**TRANSMITTAL OF RESPONSES TO U.S. ENVIRONMENTAL PROTECTION  
AGENCY AND OHIO ENVIRONMENTAL PROTECTION AGENCY COMMENTS ON  
THE DRAFT WAC ATTAINMENT PLAN FOR SEDIMENT IN THE STORM WATER  
RETENTION BASINS**

**RESPONSES TO  
U.S. ENVIRONMENTAL PROTECTION AGENCY AND  
OHIO ENVIRONMENTAL PROTECTION AGENCY  
COMMENTS ON THE DRAFT WAC ATTAINMENT PLAN  
FOR SEDIMENT IN THE  
STORM WATER RETENTION BASINS**

**FERNALD CLOSURE PROJECT  
FERNALD, OHIO**

**RESPONSES TO U.S. ENVIRONMENTAL PROTECTION AGENCY  
TECHNICAL REVIEW COMMENTS ON THE  
DRAFT WAC ATTAINMENT PLAN FOR  
SEDIMENT IN THE STORM WATER RETENTION BASINS  
(20500-PL-0004, REVISION A)**

FIGURE 5 2005 SAMPLING RESULTS

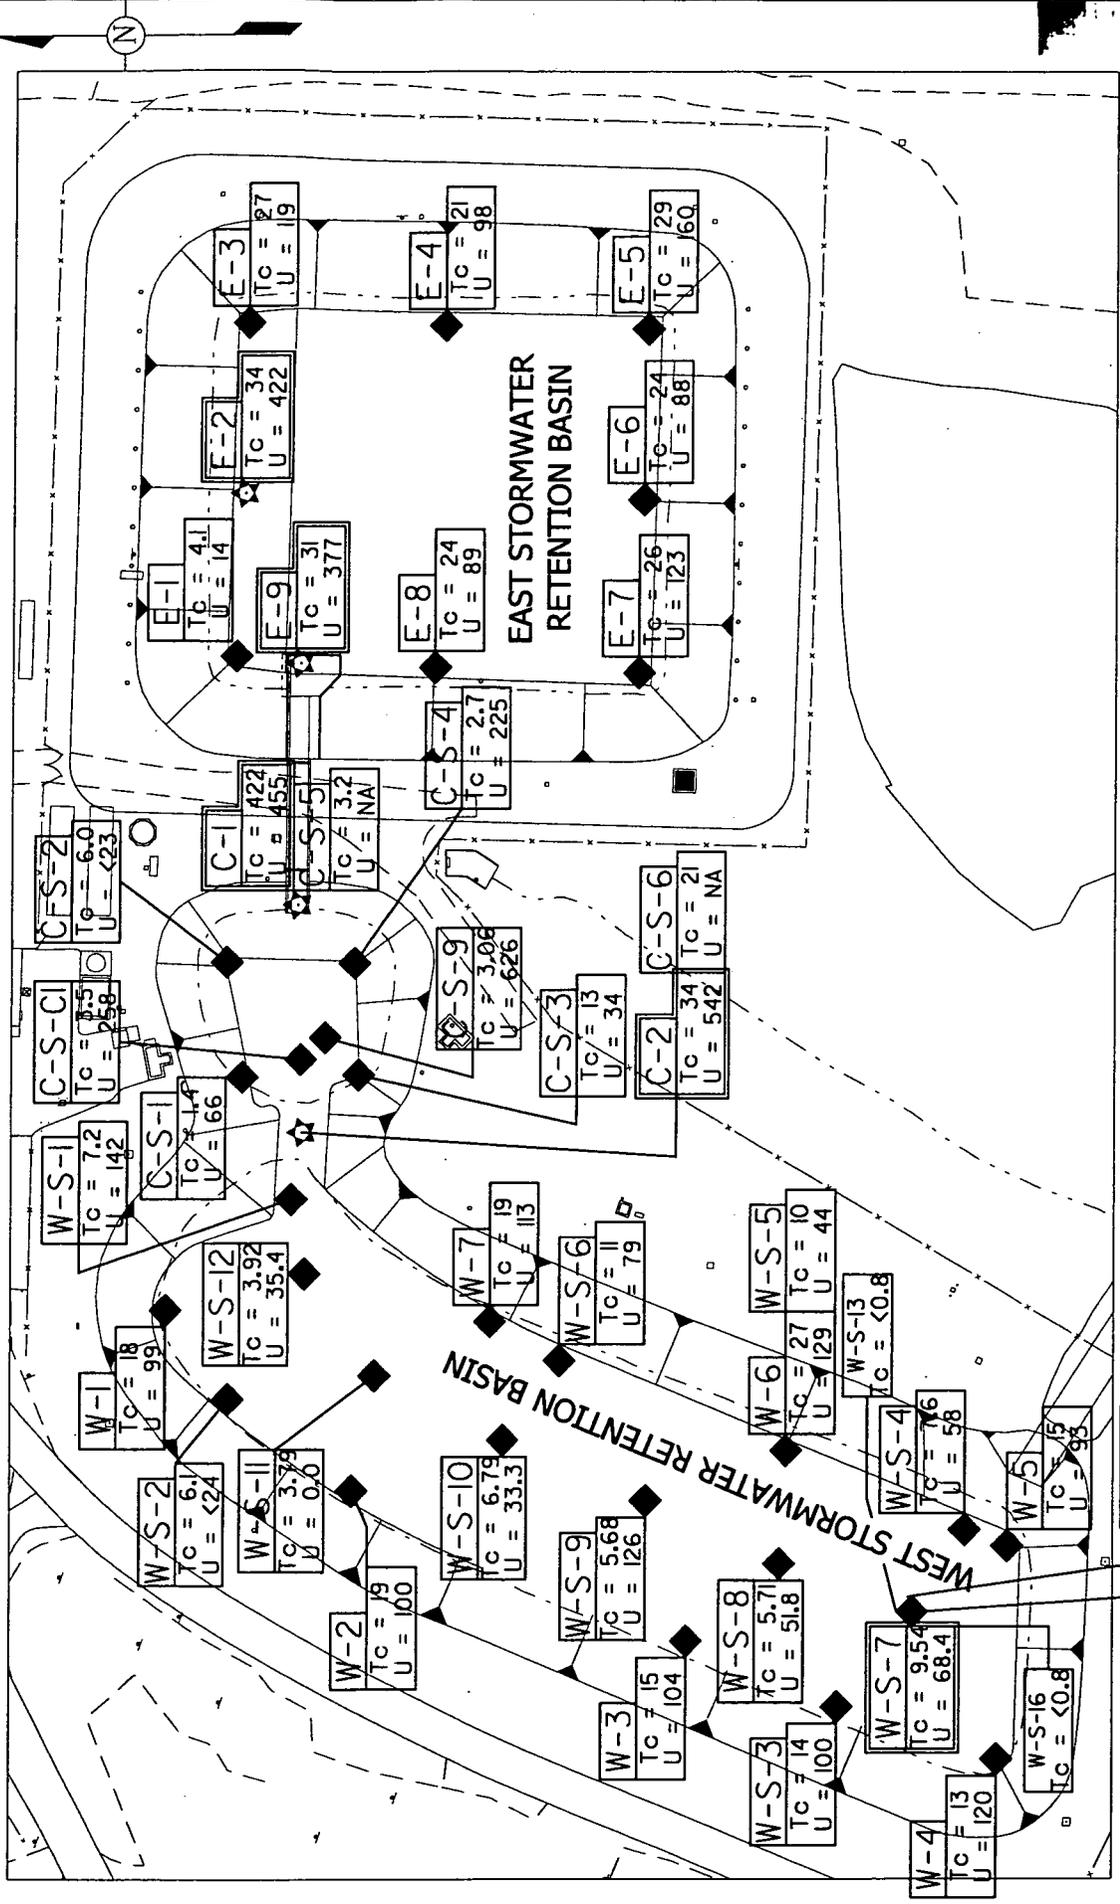
**Comment:** The text states that two sediment samples collected in 2004 from the Center and East Basins each were above the waste acceptance criteria (WAC) for technetium-99 and that all sediment samples collected from the West Basin were below-WAC for uranium and technetium-99 and refers to Figure 1. The text should be revised to state the WAC for uranium and technetium-99, the constituents of concern for the Storm Water Retention Basins. Also, according to Figure 1, all sediment samples were collected from the perimeter of the three basins. Additional sediment samples should be collected from the center (deeper) parts of the basins to make a proper WAC attainment determination for the three Storm Water Retention Basins. The appropriate sections of the plan should be revised accordingly.

**Comment:** The text states that two samples collected in 2005 from the Center Basin were greater than the '20 times rule' for total selenium and refers to Figure 2. Figure 2 indicates that the four sediment samples collected from the Center Basin were collected from the perimeter of the basin and not the center (deeper) part. Additional sediment samples should be collected from the center of all three Storm Water Retention Basins and analyzed for Envirocare WAC parameters. The appropriate sections of the plan should be revised accordingly.

**Response:** Agree. The deeper portions of the basins were characterized by adding six locations to the center of the west basin and an additional location was collected in the center of the middle basin. Once off line, the east basin will be re-sampled as well. These new data from the west basin reaffirm the conclusion that the west basin meets the On-Site Disposal Facility (OSDF) WAC. Based on the visual indications of resin in the center basin, the center basin does not meet the OSDF WAC and will therefore be sent to Soil Stockpile (SP) 7 for off-site disposal. The additional sample results from the middle basin for Envirocare WAC are consistent with all previous samples from this basin.

**Action:** The text will be revised to list the WAC for both uranium and technetium-99. Additionally, the text will be revised to incorporate the description of this most recent sampling activity and to provide discussion of the results from these samples.

**Response:** Agree. Each of the additional samples described in the above response (U.S. EPA Specific Comment No. 1) were analyzed for the Envirocare WAC parameters.

**Action:** The text will be revised to incorporate the description of this most recent sampling activity and to provide discussion of the results from these samples including the Envirocare WAC parameters.
